FINAL MITIGATION PLAN Seniard Creek Mitigation Site

Henderson County, NC DMS Project Number: 100017 Contract Number: 7189 RFP: 16-006991 USACE Action ID: SAW-2017-01571 DWR Project Number: 20171160

Re: NCIRT Review and USACE Approval of the NCDMS Seniard Creek Mitigation Site / Henderson Co./ SAW-2017-01571/ NCDMS Project # 100062

SUBJECT: Seniard Creek Mitigation Site - NCIRT Comments during 30-day Mitigation Plan Review

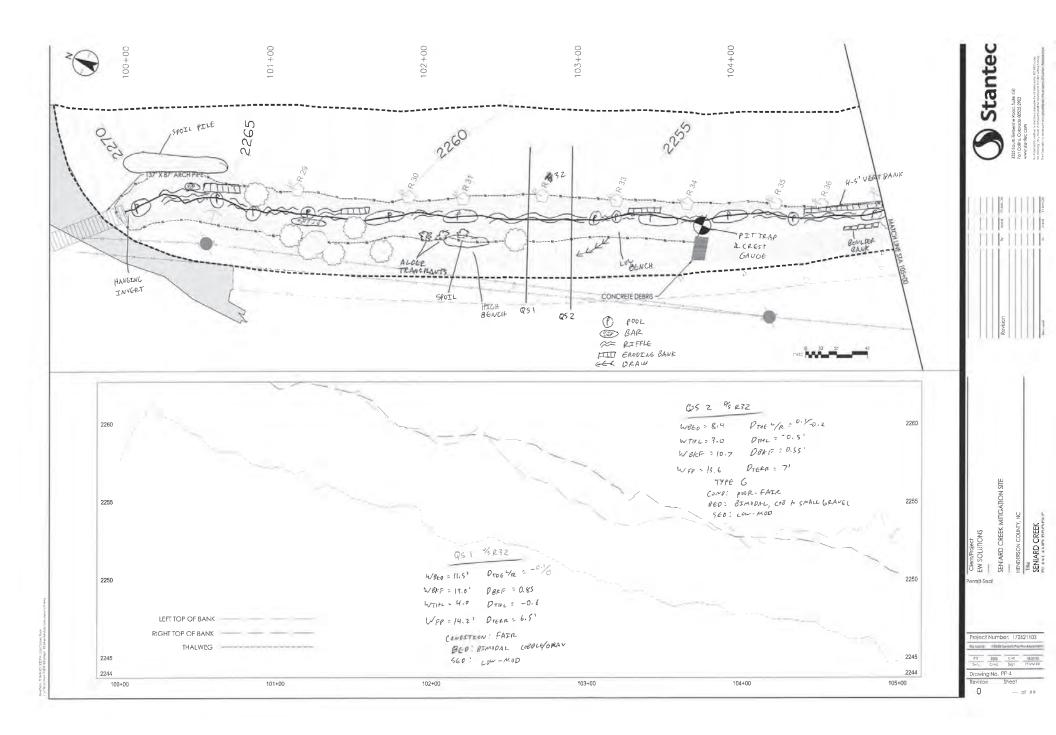
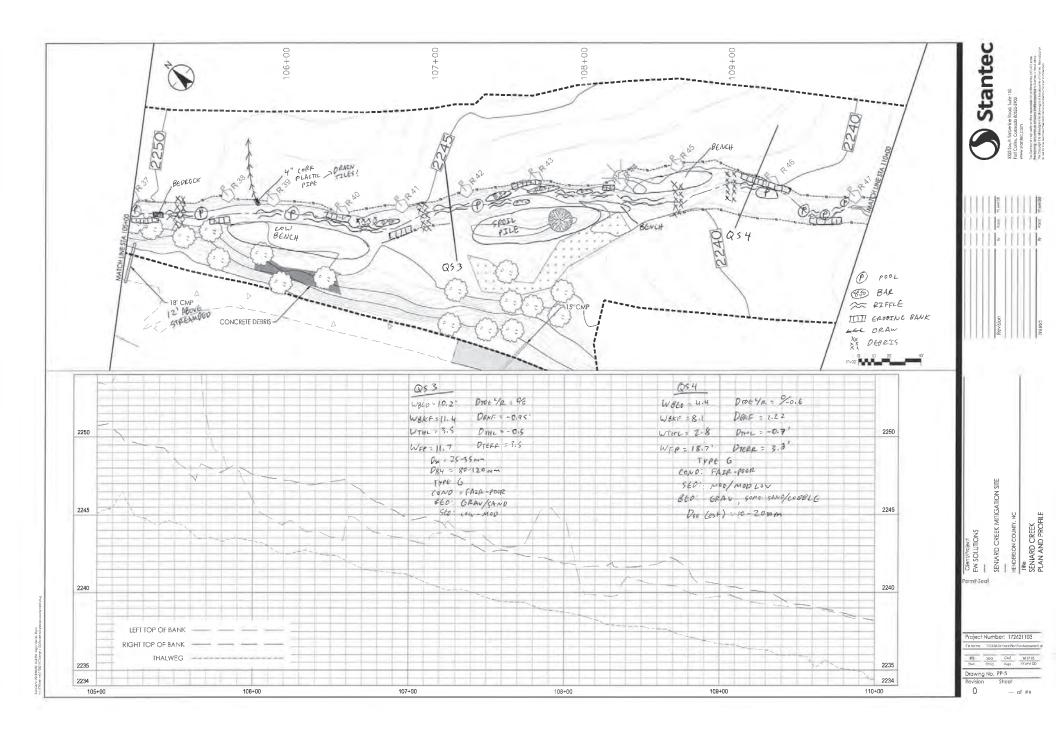
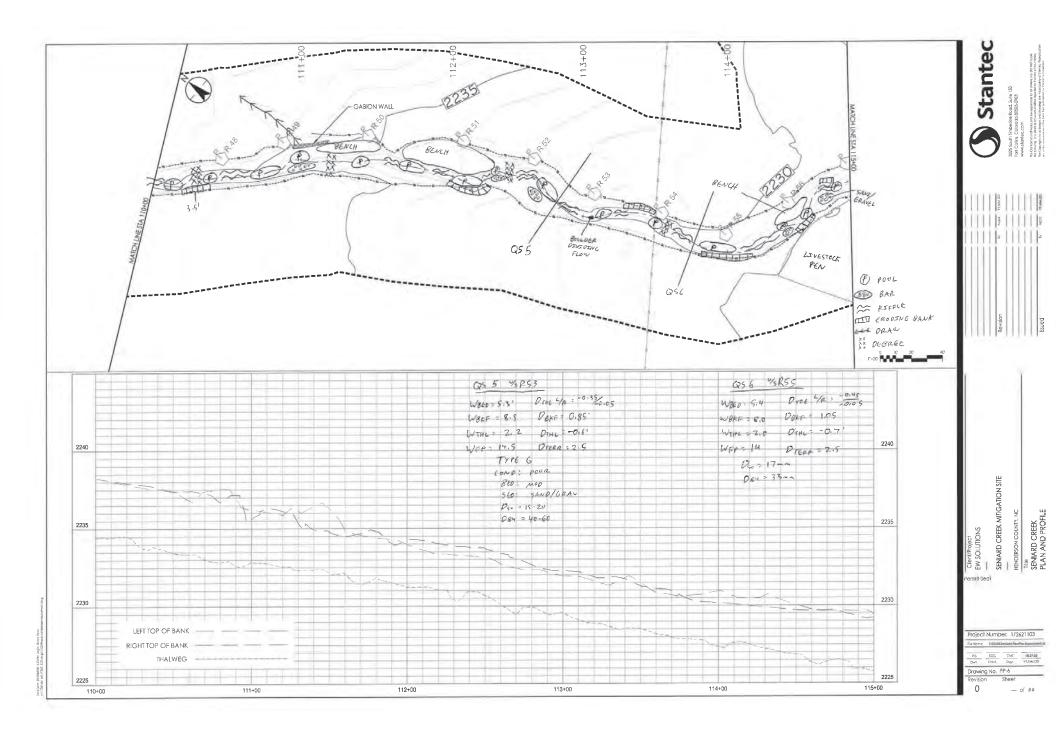
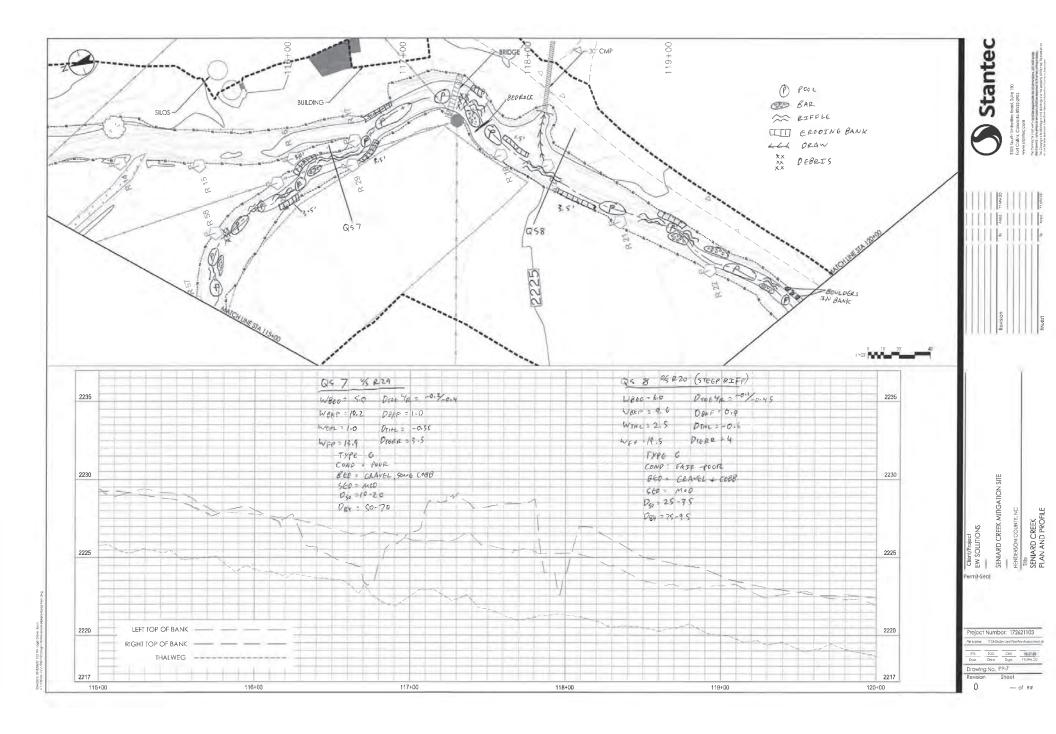
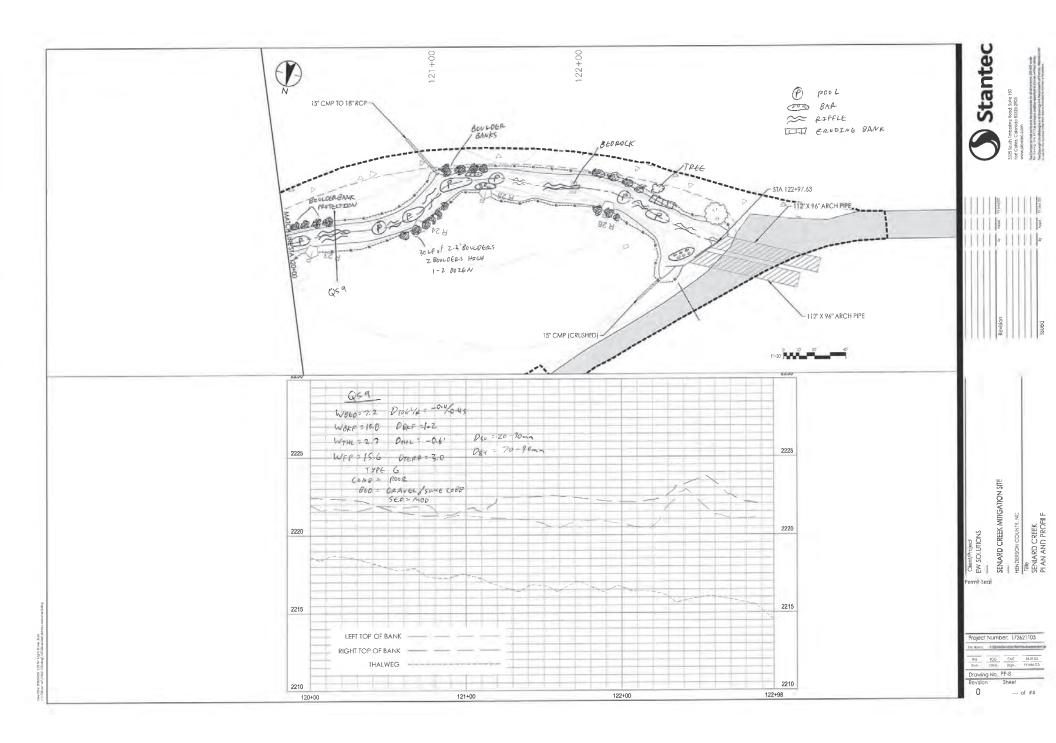
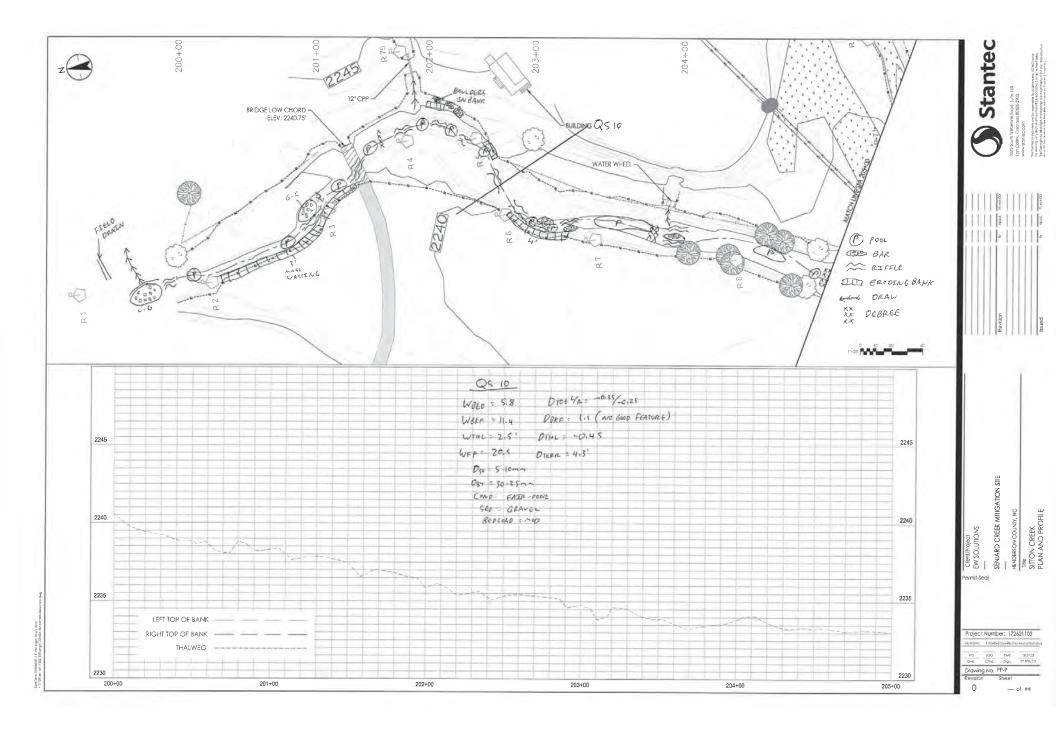
- 5. Appendix A- Photo Log- There were no photos of Whitaker or Redmond Branches.
- 6. Design sheets- Sheet 1A- it is likely that the riparian area between Sitton and Seniard will wet up considerably. In fact, it is likely to wet up outside the current easement lines. DWR suggests the easement be adjusted to account for this possible condition. In the past, the IRT has seen landowners come in a ditch immediately adjacent to the easement thereby decreasing the functional uplift of the adjacent wetlands. While DWR realizes there is not wetland credit on this site, one of the main reasons we are allowing the channel on Sitton to be moved is because of the restoration of the riparian wetlands.

Comment: (5) Appendix A- Photo Log- There were no photos of Whitaker or Redmond Branches.

Response: Photos of Whitaker and Redmond Branches have been added to the photo log.
